RECEIPT DATE: 8/23/18 **ONSITE SEWAGE DISPOSAL SYSTEM** P 563990
 APPROVAL DATE: 10/16/2018 **PERMIT: CONSTRUCTION** A _____
 PROPERTY ADDRESS: 13185 Highland Road
 SUBDIVISION: Sullivan Property LOT: 2 TAX ID: 05-368561
 CONTRACTOR: Fogle's Septic Clean, Inc. EMAIL: kurt@foglesinc.com
 CONTRACTOR ADDRESS: 580 Obrecht Road, Sykesville, MD 21784 PHONE: 410-795-5670

RE: OSDS Plan
Sullivan Property, Lot 2
13185 Highland Road

SITE PLAN FOR BAT INSTALLATION

SULLIVAN PROPERTY
 PARCEL 2
 13185 HIGHLAND ROAD
 HIGHLAND, MD 20777
 3.01 AC.

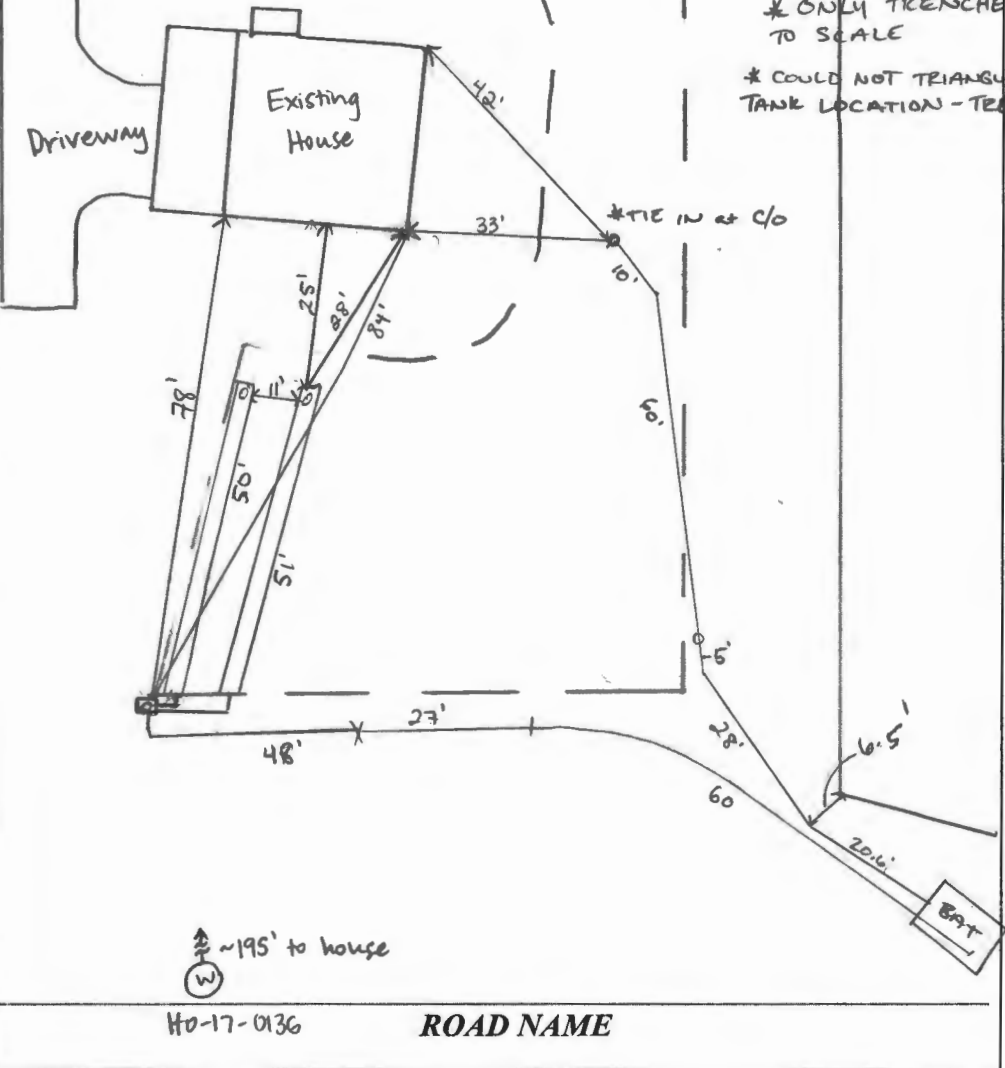
* ONLY TRENCHES TO SCALE
* COULD NOT TRIANGULATE TANK LOCATION - TREES

9/17/18 Met Fogle's, Mrs. Sullivan, and her son, John, on site for layout. Property corners, SDA corners, + BAT tank staked. Mrs. Sullivan would like to keep azalea bushes between SDA w/ initial system + house. OK to move D-box to corner farther from house. Shot contour + laid out 2 x 50' trenches. Pulled 100' off well, force main will be outside 100' arc. Existing tank + drywell must be pumped + abandoned. (SC)

INSTALLATION: 9/21/2018 (AM) TRENCHES IN PROGRESS OF CONSTRUCTION. (PM) TRENCHES COMPLETE. ~2 PERFORATIONS OF TRENCH LATERAL START BEFORE TRENCH AGGREGATE. TRENCHES WERE BACKFILLED IN CENTER AND COULD NOT REMEDIATE. (AM) 10/5/2018 (AM) TANK SET. INSTALLING HOUSE EFFLUENT LINE. (PM) FORCE MAIN COMPLETED AND HOUSE EFFLUENT LINE CONNECTED TO TANK. REINSPE P/A (AM) 10/15/2018 PUMP + ALARM. OK. RECEIVED CONFIRMATION OF AB. S.T. + D.W. LOCATION OF EX ST + D.W APPEARED TO BE BACKFILLED. (AM)

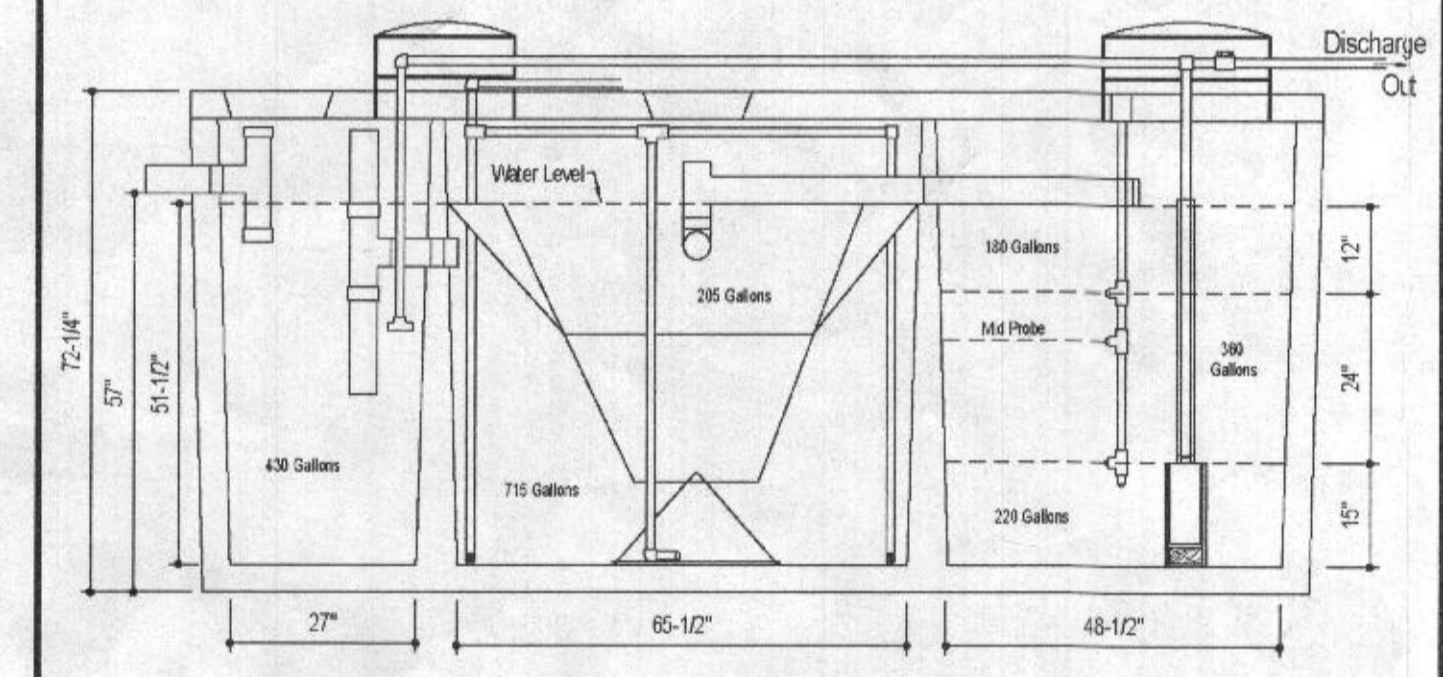
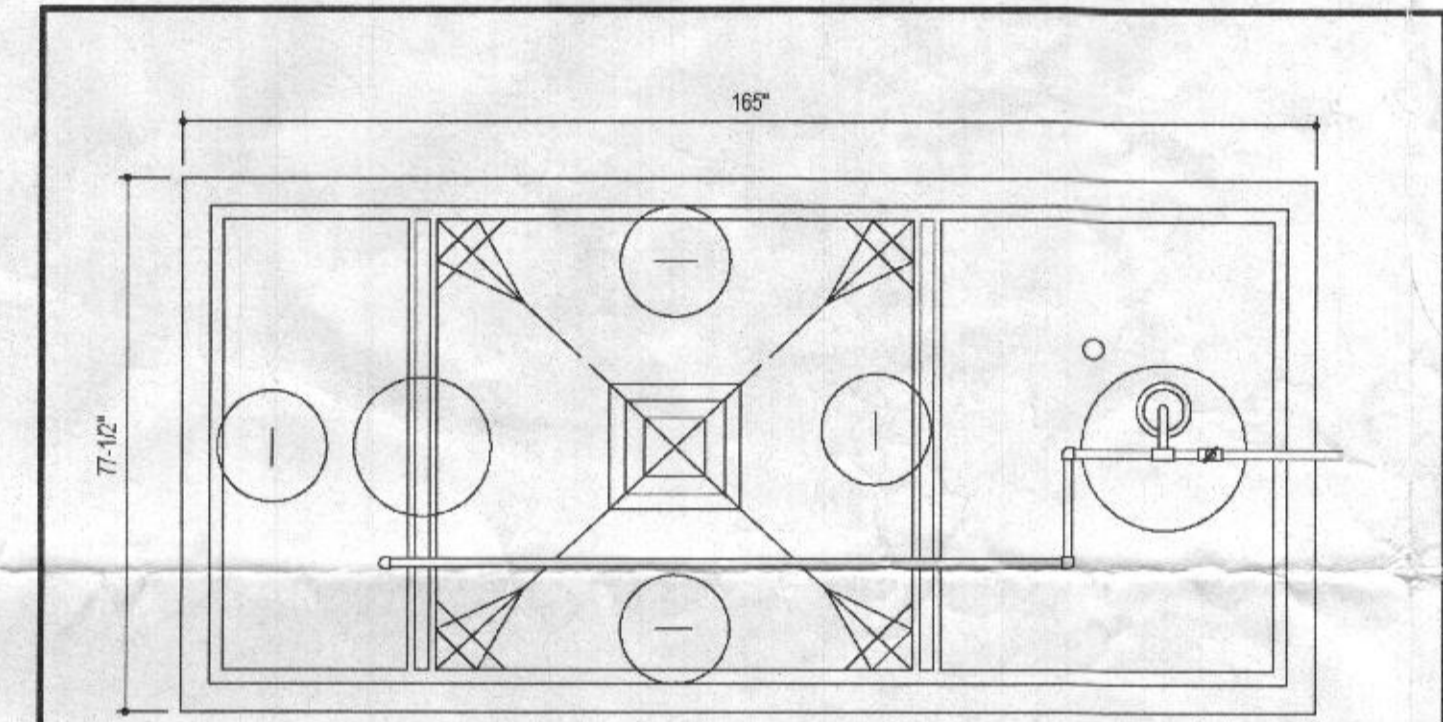
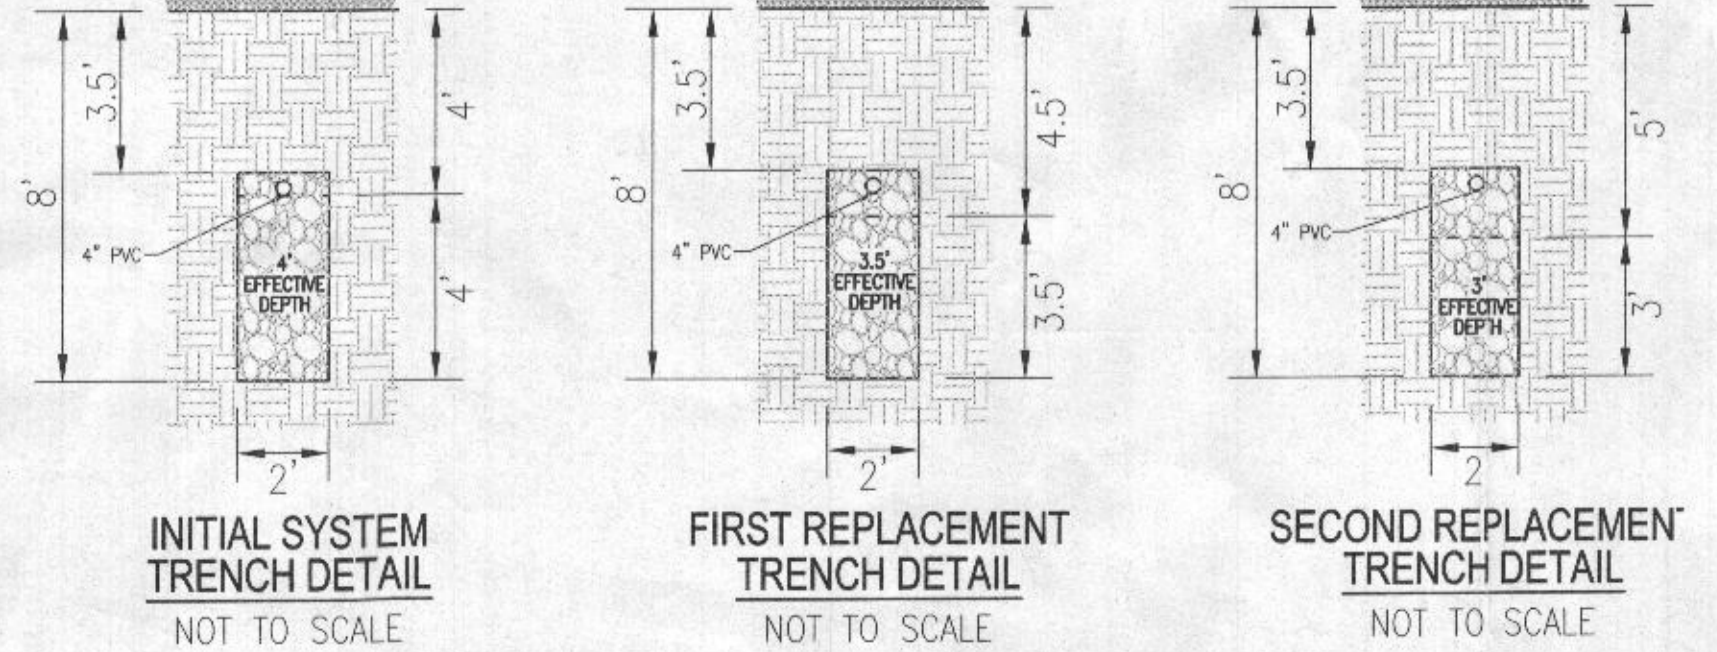
Few things on my review of lot 2 resubmittal that needs to be addressed:

- The **1st replacement system** should utilize a 0.6gpd/ft² loading rate instead of a 1.2 gpd/ft². The system is tailored more towards perc holes 111 and 110 based on current elevations and topography shown. The sidewall credit should also be changed to 3.5ft instead of 4ft. The design will be as follows:
 $450\text{gpd} \div 0.6\text{gpd/ft}^2 = 750\text{ ft}^2 \div 2 \text{ (trench Width)} = 375\text{ft} \times .40 \text{ (sidewall reduction for 3.5ft)} = \underline{150\text{ Linear feet}}$.

- In lieu of this change, please add another 50ft trench below the existing 2 x 50ft trenches already shown for the 1st replacement system.
- The trench detail section will need to be changed to reflect the new 2nd replacement trench spec's.

- The electric to the house must either be labeled "to be relocated in the future prior to installing the 2nd replacement system" or there must be a 5ft setback on both sides of the electric line that "*is to remain*" and labeled as such. If the electric line "*is to remain*", you will also need to revised the percolation certification plan to reflect this change in the SDA. Area would be deleted and added to part of the SDA (keeping the minimum 10,000sq ft area).

- The 2nd replacement system is shown going thru the existing electric line and the existing large trees which would need to be adjusted for the comment above; depending on which way you choose. Trees would need to be labeled "to be removed prior to installing 2nd replacement" or trenches relocated around them.

- You show an ex. electric line running parallel with the 'use-in-common'. I am not sure what this line is but the owner (Patricia Sullivan) has stated to me that this may be an old underground dog fence. This should be either removed or labeled as such.

1. The SDA and lot lines were not staked
2. There is an existing gravel drive that is faintly shown on the OSDS plan that runs laterally next the distribution box. The elevation of the drive way has cut the grade down enough to alter the location of the trench # 2 running towards perc hole 108. This topo will need to be reflected on the OSDS plan (i.e. field-run may be required).

3. The initial system has 2 very large trees directly in the way of the location of the trenches. These trees need to be shown on the OSDS plan and labeled either "to remain" or "to be removed".

4. The main electric comes off a pole from the use-in-common to supply the house. This will need to be shown on the OSDS.
5. The OSDS plan shows an ejector pit inside the house. This does not exist as basement service is via gravity. The elevations and location of the BAT unit will not work at these elevations. You will need to coordinate with the owner on how you want to proceed (i.e. installation of an ejector pit as per the OSDS plan, or try and relocate the BAT w/a pump tank).

FIRST REPLACEMENT SYSTEM:
 3 BEDROOMS AT 450gpd / 0.6 ABSORPTION RATE = 750 SQ. FT.
 750 SQ. FT. / 2 (TRENCH WIDTH) x .40 (SIDEWALL REDUCTION) = 150 LINEAR FEET
 150 TOTAL LINEAR FEET OF TRENCH ARE PROVIDED WITH THE INITIAL SYSTEM.
 (3 TRENCHES OF 50 FEET IN LENGTH)
